Teeple Architects INC.

Package 3 - Level 2

- Review
- parapet heights
 - revised bottom of wall dimensions at 350mm curbs.
 - operable windows.

PROJECT NAME	SQ ALEXANDRA PARK - BLOCK 11
DRAWING TITLE	2nd FLOOR KEY PLAN
ARCHITECT	TEEPLA ARCHITECTS
CONTRACTOR	TRIDEL
SCALE	N/T/S
DRAWN BY	S.C.
DATE	MARCH 4, 2015

PROJECT NAME: SQ ALEXANDRA PARK - BLOCK 11		DRAWING No.: E2-2
DRAWING TITLE: 2nd FLOOR ELEVATIONS		
ARCHITECT: TEEPLE ARCHITECTS		DATE: MARCH 4, 2015
CONTRACTOR: TRIDEL		
SCALE: 1:50	DRAWN BY: S.C.

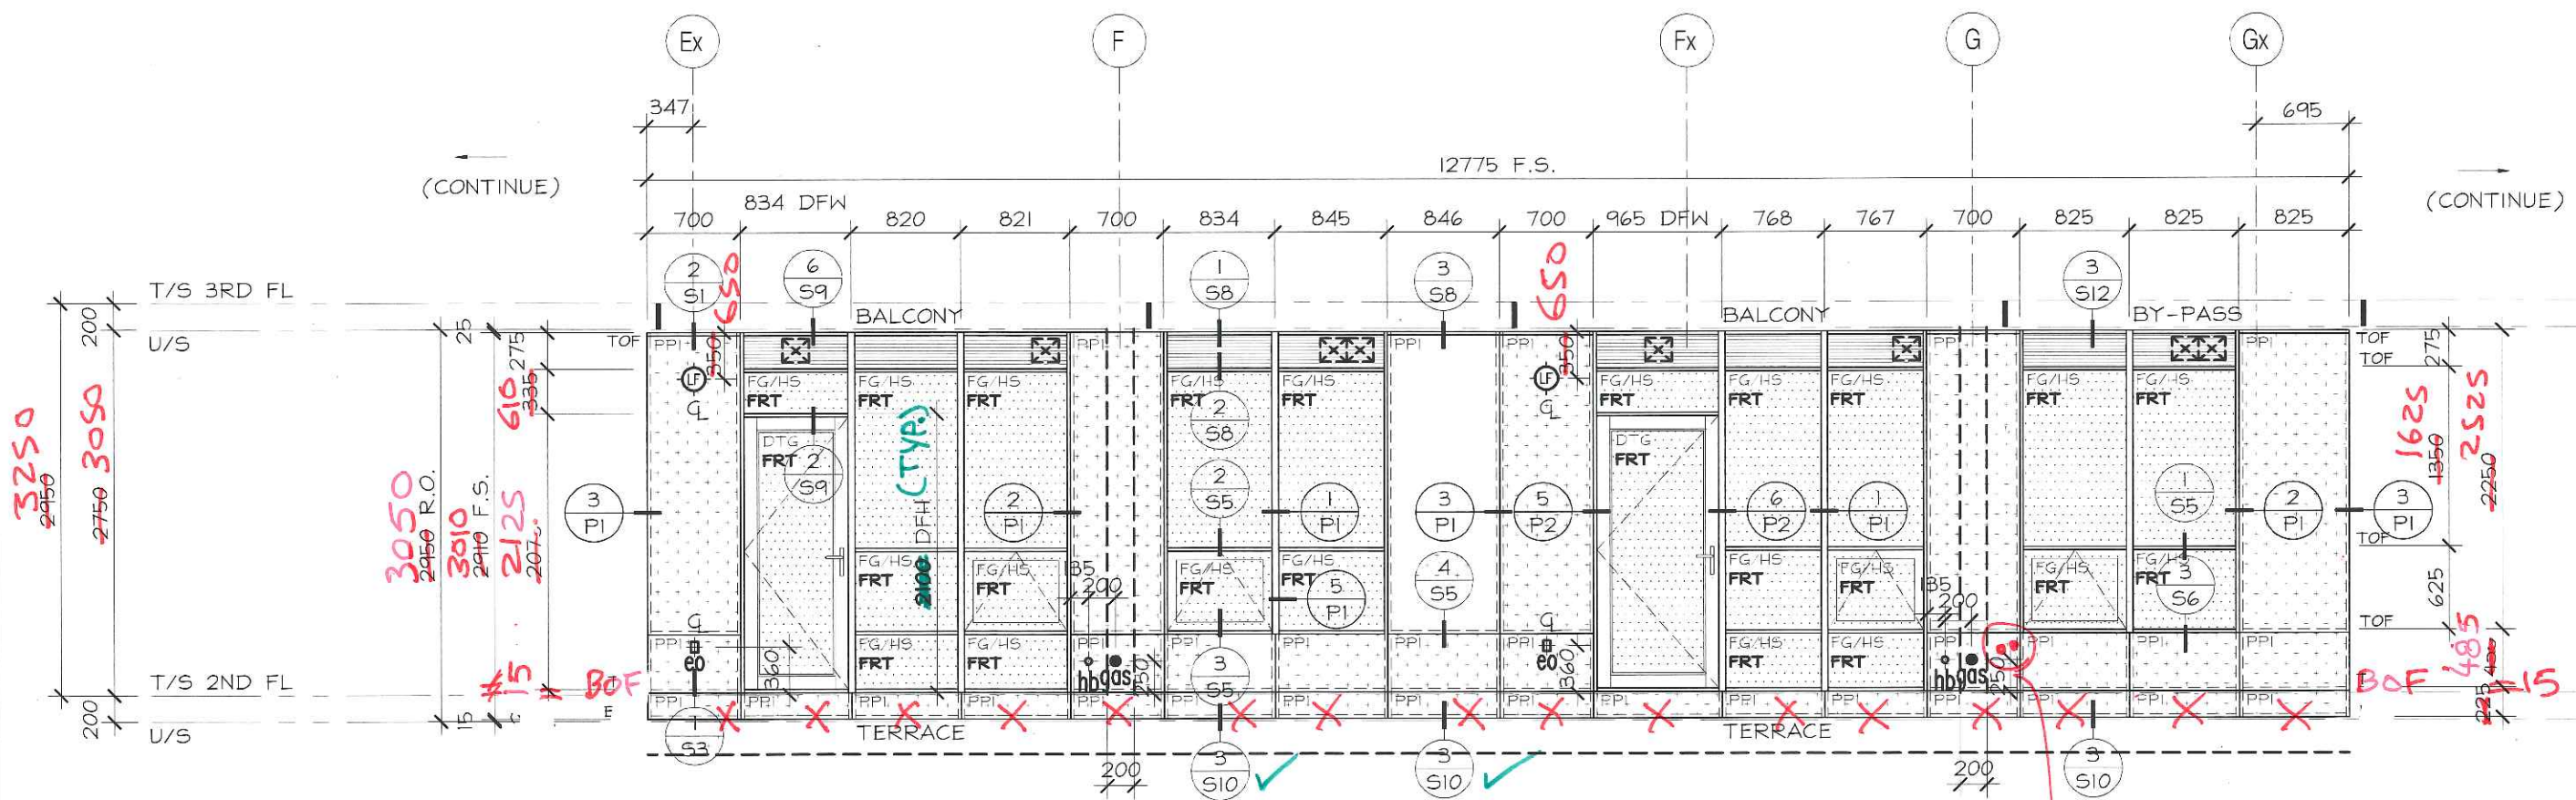
hb+gas
to move from other
side of unit

DRAWING No.:
E2-5

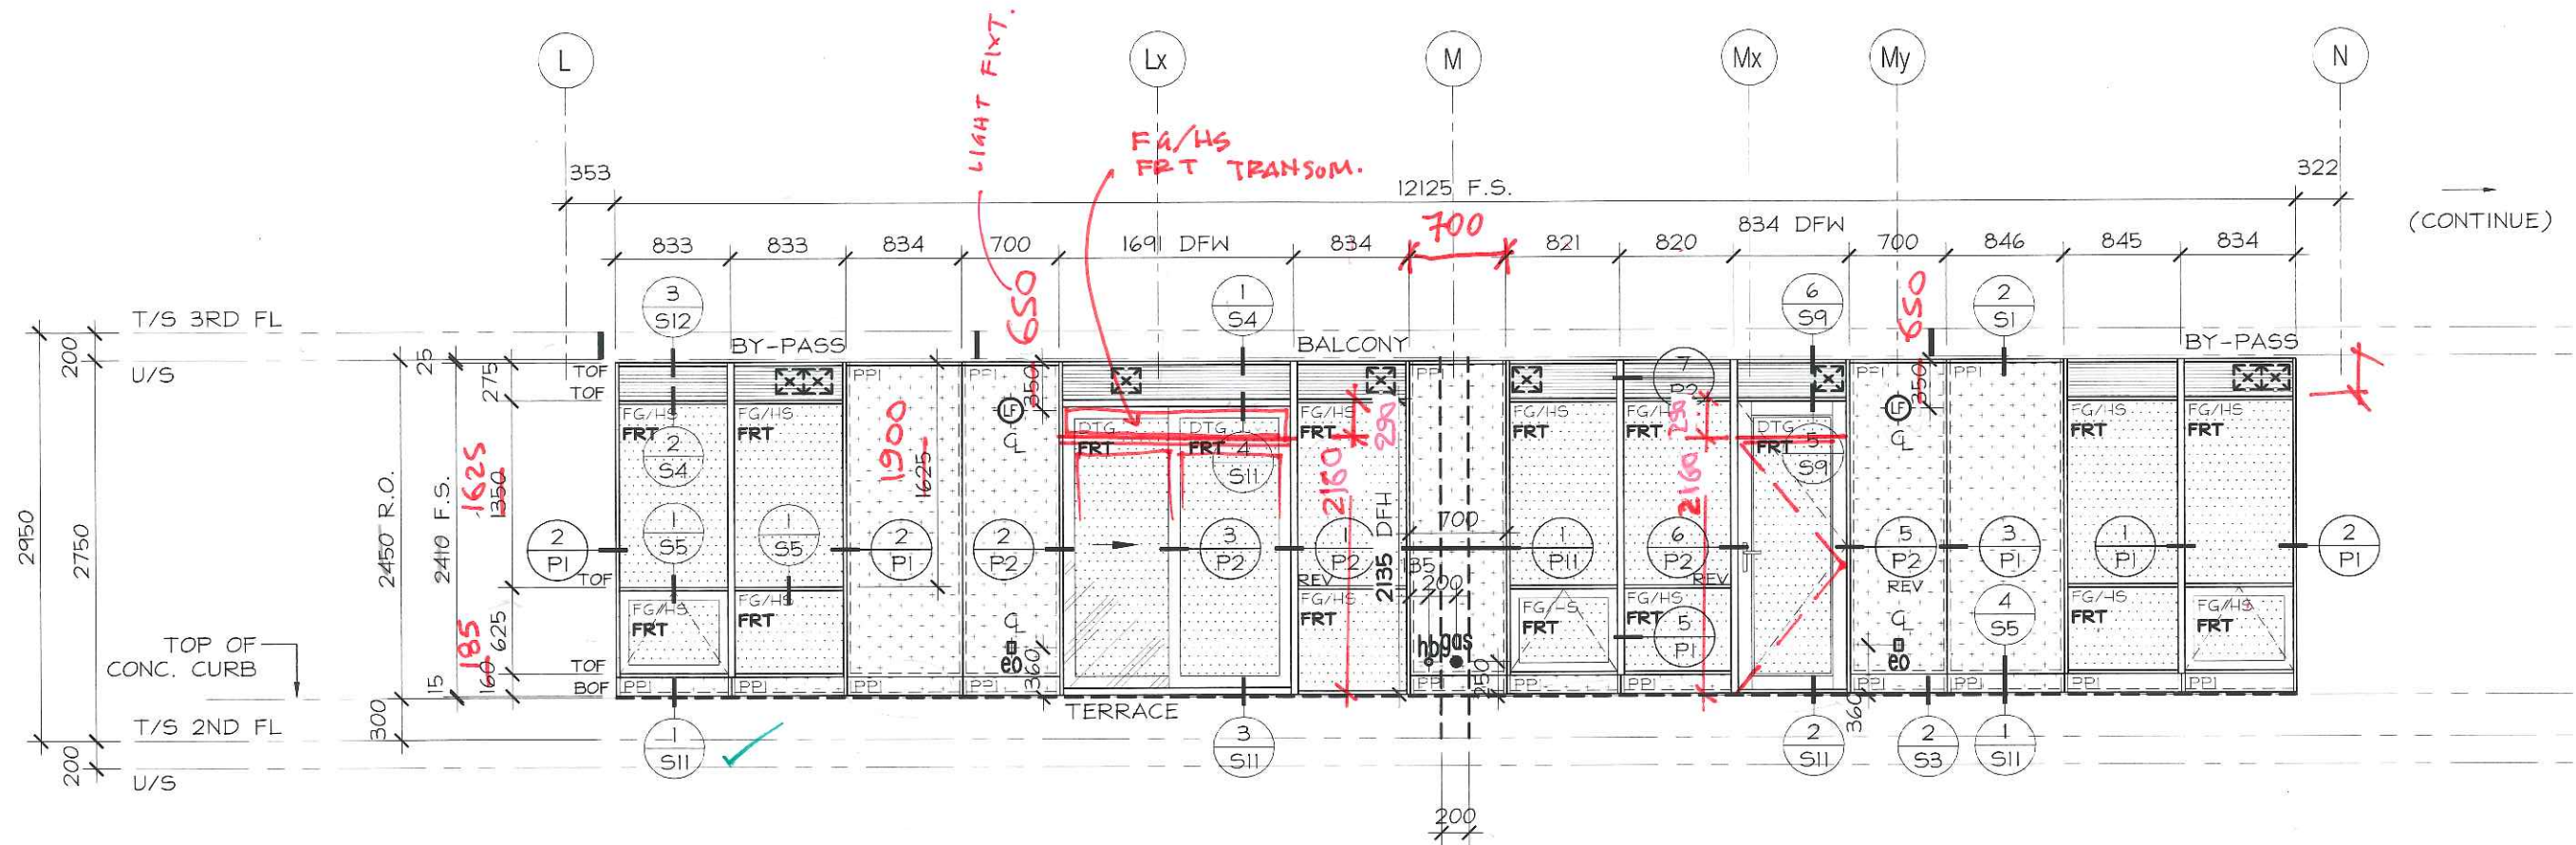
Flow to floor increased.

PROJECT NAME:	SQ ALEXANDRA PARK - BLOCK11		
DRAWING TITLE:	2nd FLOOR ELEVATIONS		
ARCHITECT:	TEEPLE ARCHITECTS		DRAWING No.:
CONTRACTOR:	TRIDEL		E2-14
SCALE:	1:50	DRAWN BY:	S.C.
DATE:	MARCH 4, 2015

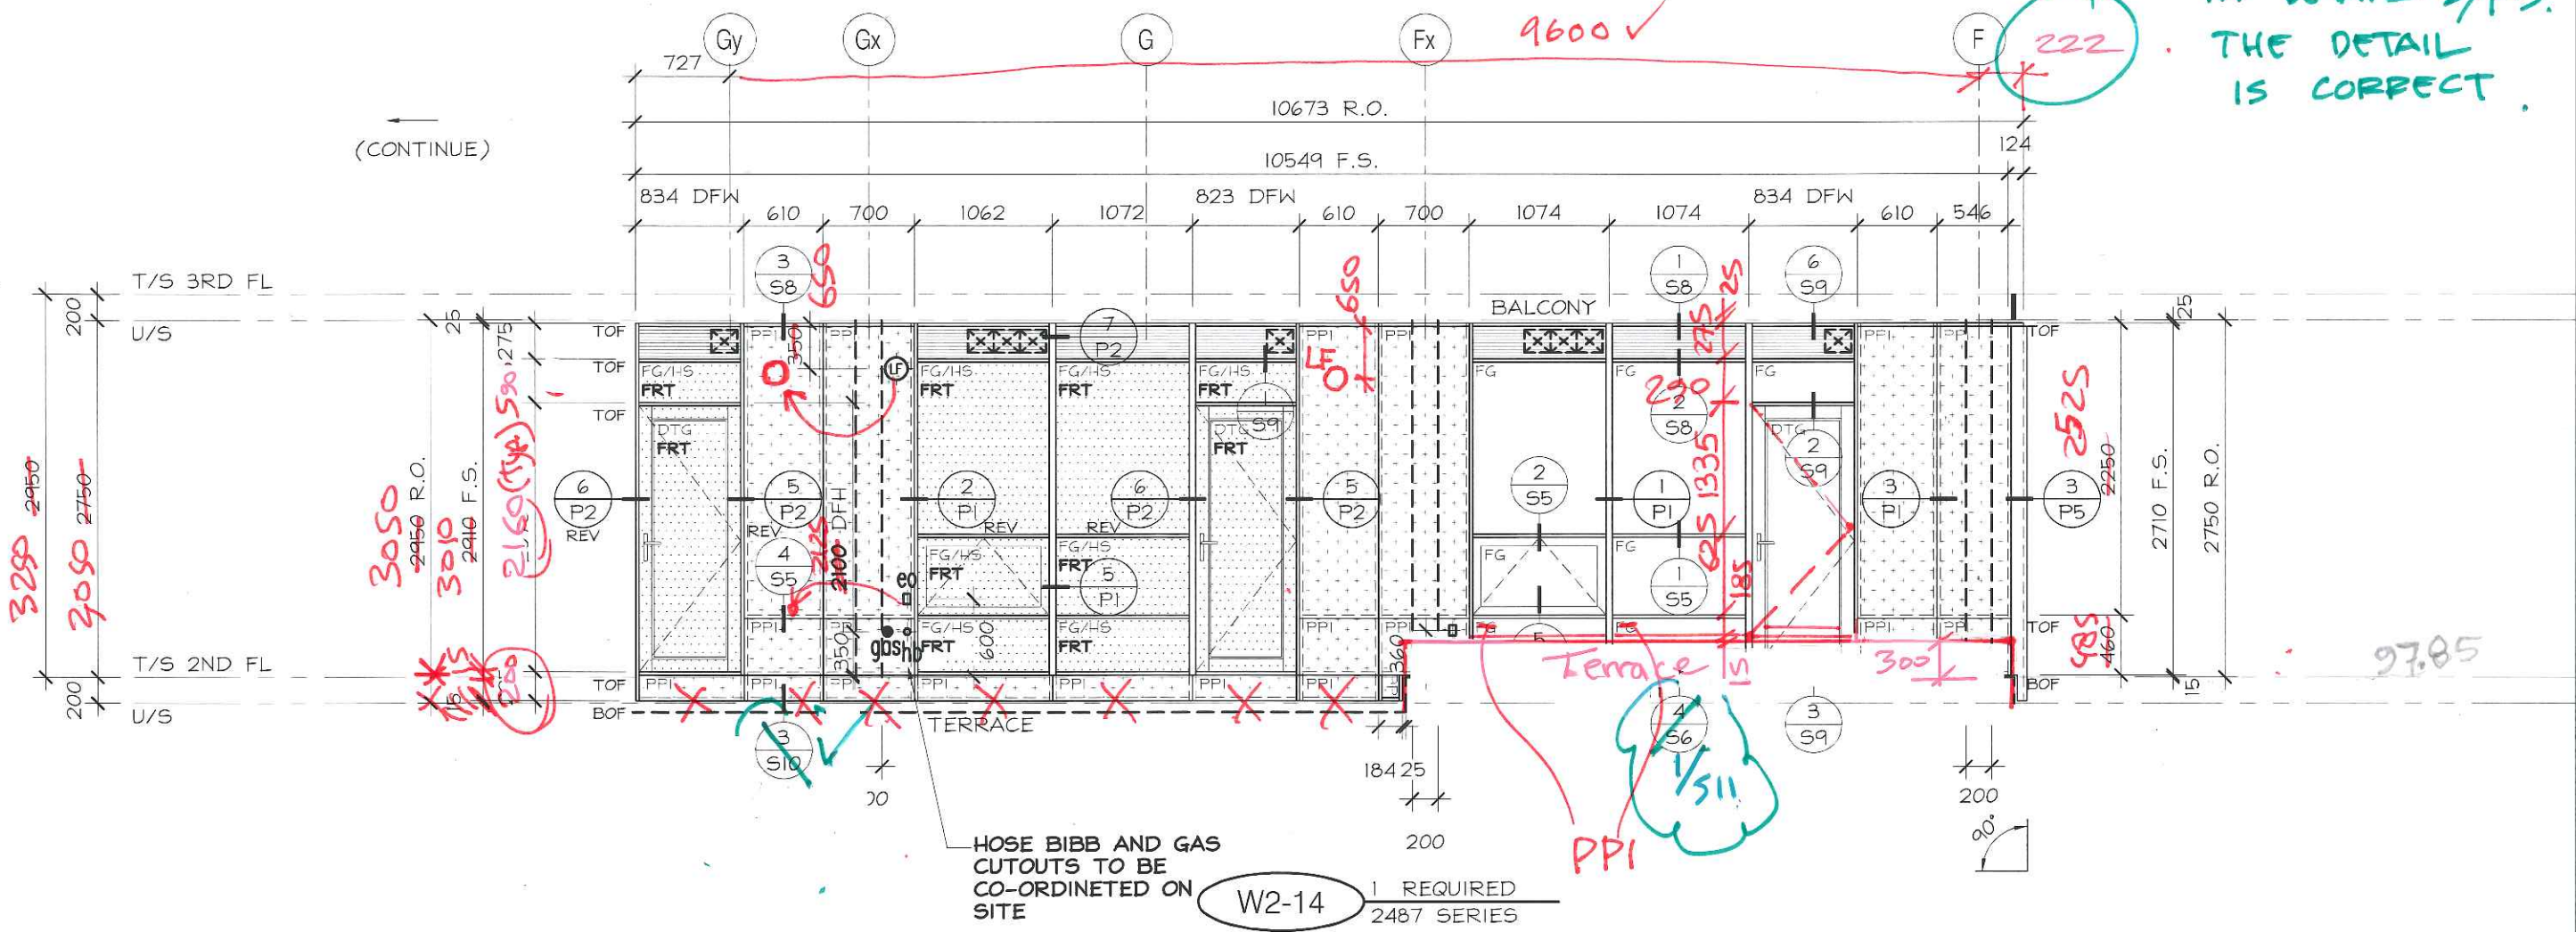
PROBLEM.
 THIS DIM IS 347 IN DETAIL S/PS. THE DETAIL IS CORRECT.
